TCEQ Public Meeting Form
April 9, 2015

Lower Colorado River Authority
Water Quality TPDES Permit Renewal
Permit No. WQ0002105000

RE: Notice of Application and Intent to Obtain Water Quality Permit Renewal for the LCRA Fayette Power Plant, Permit No. WQ0002105000

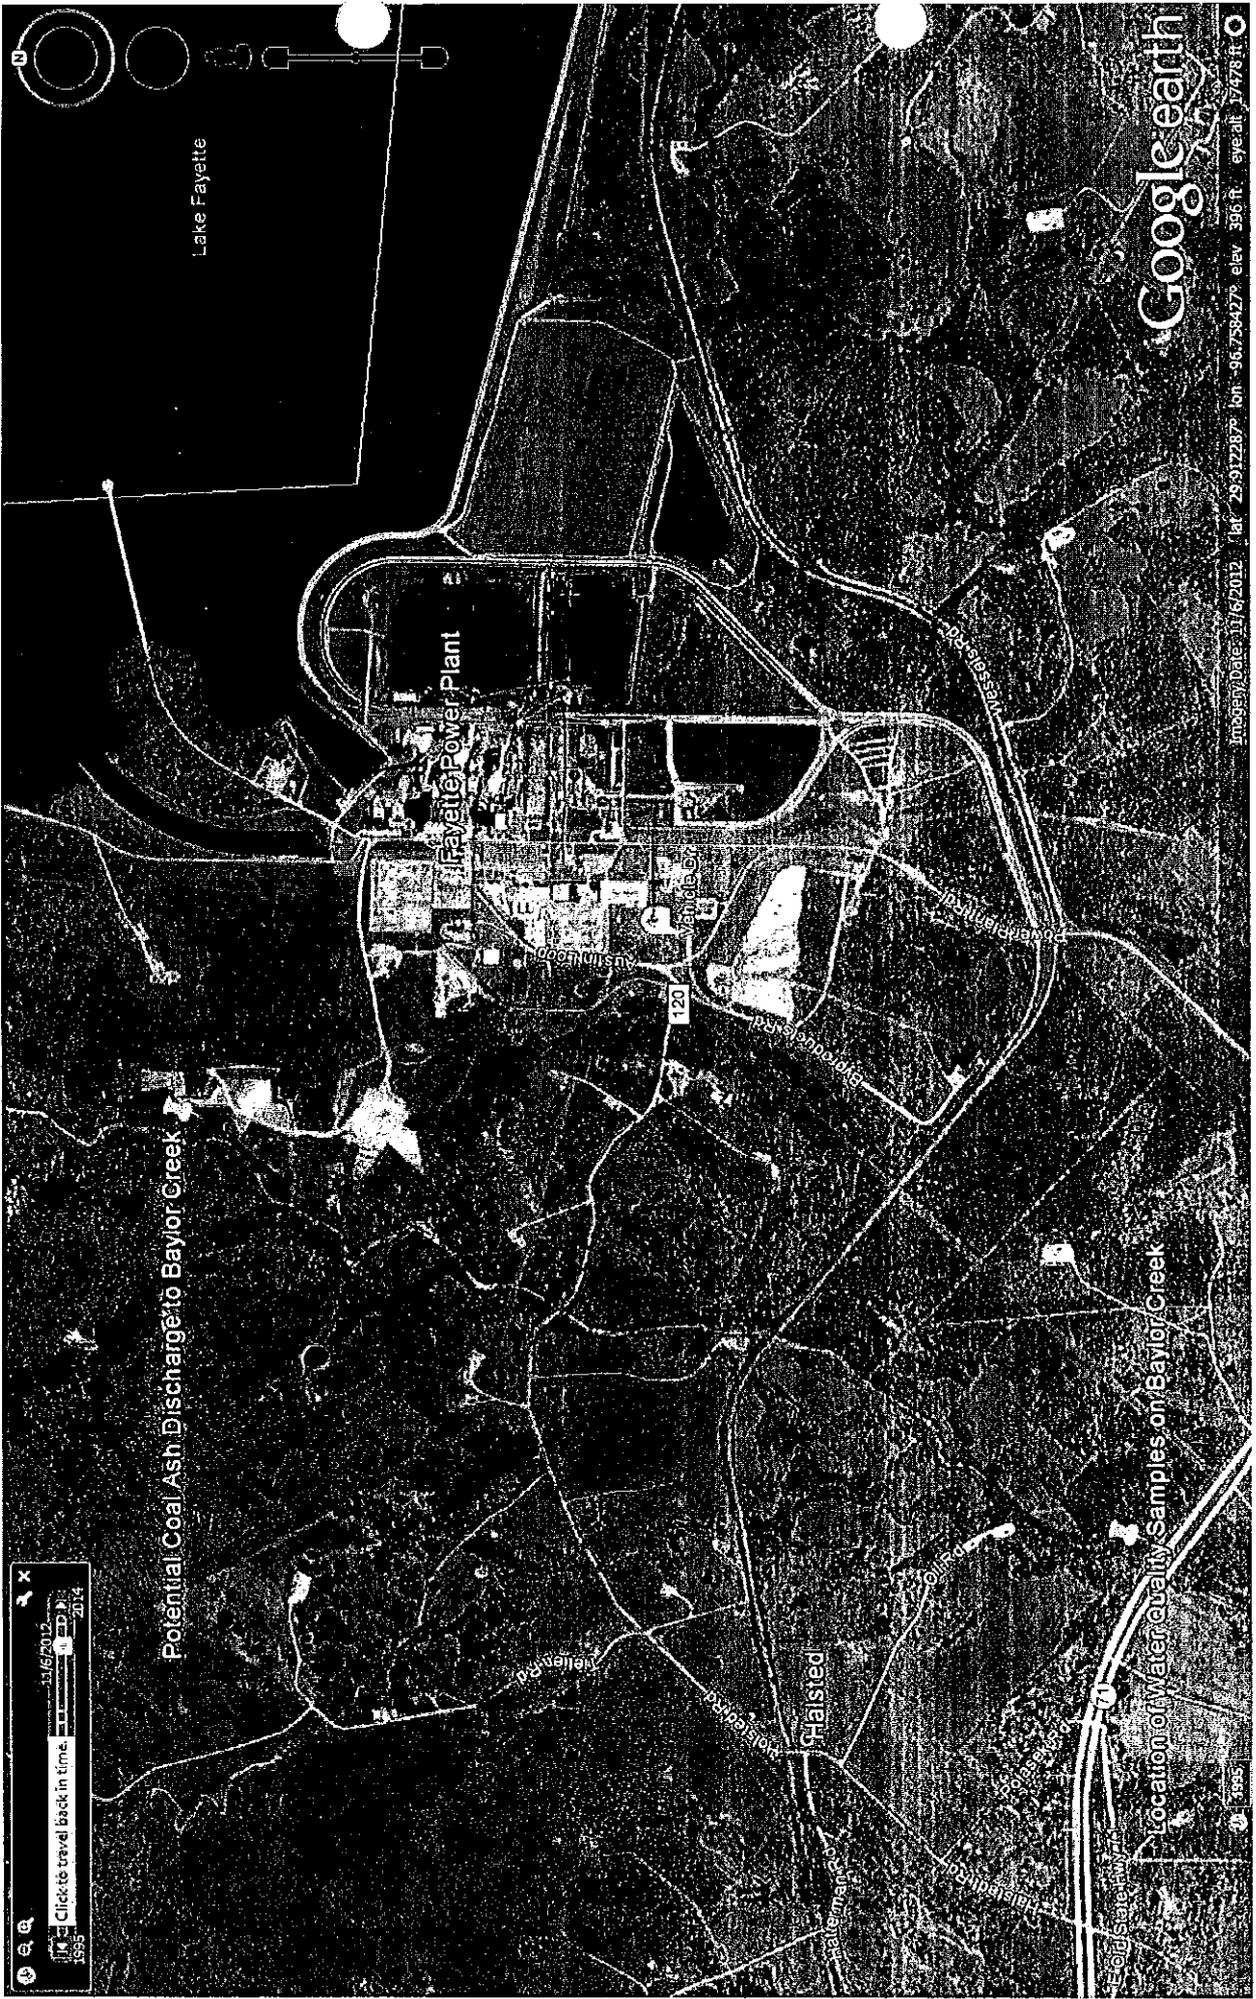
LCRA has identified four ephemeral seeps in the western portion of the facility (see Figure 13), consisting of the following:

- Construction Debris Landfill (CDL) Seep- ephemeral seep believed to be in hydraulic communication with the Middle Sand. The seep drains into an ephemeral tributary of Baylor Creek, located approximately 1600 feet to the west.

LCRA has conducted sampling of these seeps on multiple occasions. Table 12E-3 summarizes the analytical data from samples collected at these seeps beginning in 2007. The Production Engineering Seep, Waste Storage Building Seep, and Culvert Seeps have been evaluated for metals. Given the status of non- release to ecological receptors, and the expected hydraulic communication between fill materials and the Upper Sand, analytical results were compared to the Upper Sand-specific PCLs. There have been no applicable PCL exceedances.

The CDL Seep has been evaluated routinely since the 1990s for multiple analytical suites, including metals, Total Petroleum Hydrocarbons (TPH), volatile organic compounds, semivolatile organic compounds, Polychlorinated Biphenyls, Pesticides, and Herbicides. There have been no indications of environmental impact. As such, LCRA has not identified any surface water or soil impacts from any seep in the western portion of FPP and has discontinued seep monitoring.

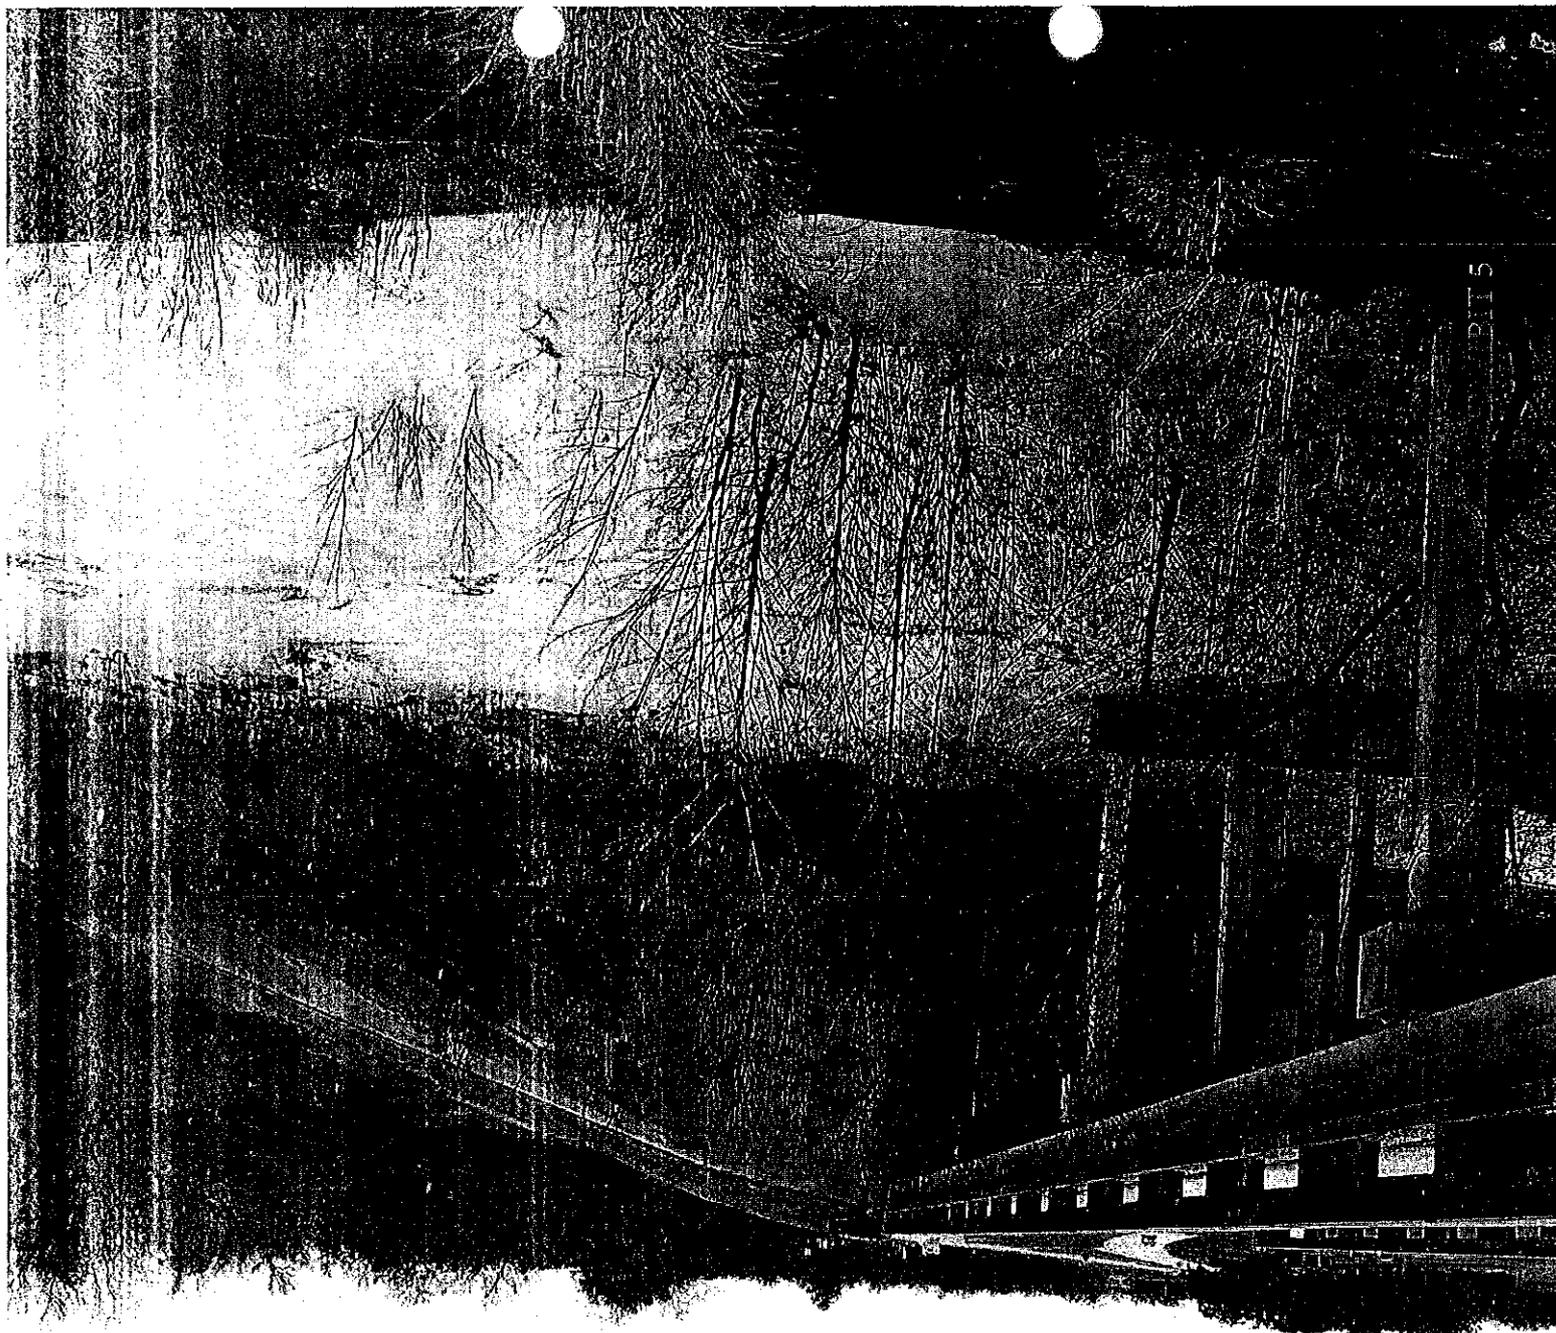
LCRA has identified four ephemeral seeps in the western portion of the facility (see Figure 13), consisting of the following:

- Construction Debris Landfill (CDL) Seep- ephemeral seep believed to be in hydraulic communication with the Middle Sand. The seep drains into an ephemeral tributary of Baylor Creek, located approximately 1600 feet to the west.

LCRA has conducted sampling of these seeps on multiple occasions. Table 12E-3 summarizes the analytical data from samples collected at these seeps beginning in 2007. The Production Engineering Seep, Waste Storage Building Seep, and Culvert Seeps have been evaluated for metals. Given the status of non-release to ecological receptors, and the expected hydraulic communication between fill materials and the Upper Sand, analytical results were compared to the Upper Sand-specific PCLs. There have been no applicable PCL exceedances.

The CDL Seep has been evaluated routinely since the 1990s for multiple analytical suites, including metals, Total Petroleum Hydrocarbons (TPH), volatile organic compounds, semivolatile organic compounds, Polychlorinated Biphenyls, Pesticides, and Herbicides. There have been no indications of environmental impact. As such, LCRA has not identified any surface water or soil impacts from any seep in the western portion of FPP and has discontinued seep monitoring.
